NP-11-0022
June 2, 2011

Subject: Exelon Nuclear Texas Holdings, LLC
Victoria County Station Early Site Permit Application
Response to Request for Additional Information Letter No. 09
NRC Docket No. 52-042

Attached are responses to NRC staff questions included in Request for Additional Information (RAI) Letter No. 09, dated May 6, 2011, related to Early Site Permit Application (ESPA), Part 2, Sections 02.05.01 and 02.05.03. NRC RAI Letter No. 09 contained twenty-three (23) Questions. This submittal comprises a partial response to RAI Letter No. 09, and includes responses to the following six (6) Questions:

**Figure 1. Location of Fault E LiDAR Profiles.**

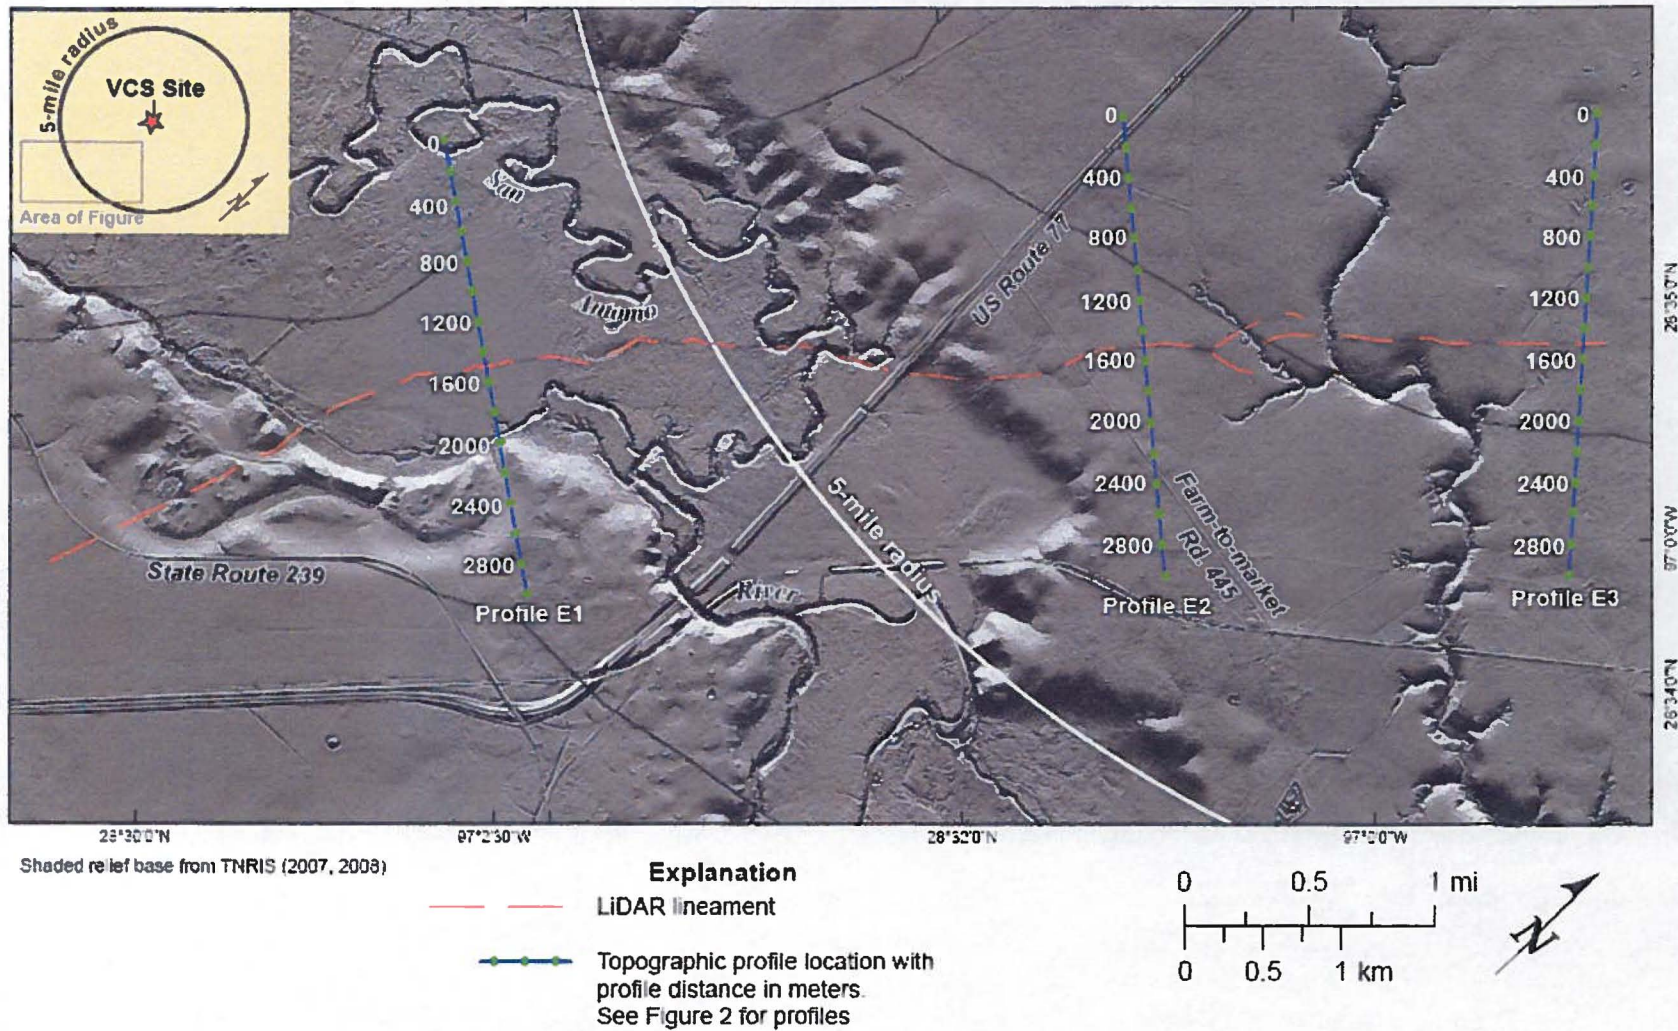
SSAR Section 2.5.1.2.4.2.4 describes fault E as having a similar geomorphic expression as fault D, which may imply that faults D and E are splays and may share a similar, contemporaneous movement history. In support of 10 CFR 100.23, please plot one or more representative LiDAR topographic profiles of faults D and E side-by-side, at the same scale and vertical exaggeration, to facilitate comparisons of their geomorphic expressions.

This similarity between the faults can be seen in Figure 2 of this RAI response, which shows topographic profiles from the LiDAR data (TNRIS, 2007, 2008) presented in the SSAR across both growth faults E and D. The profiles from growth fault D are a subset of those shown in SSAR Figure 2.5.1-50, and the locations of those profiles are shown in SSAR Figure 2.5.1-49. The growth fault E profiles were developed explicitly for this RAI response, and the locations of the profiles are shown in Figure 1.
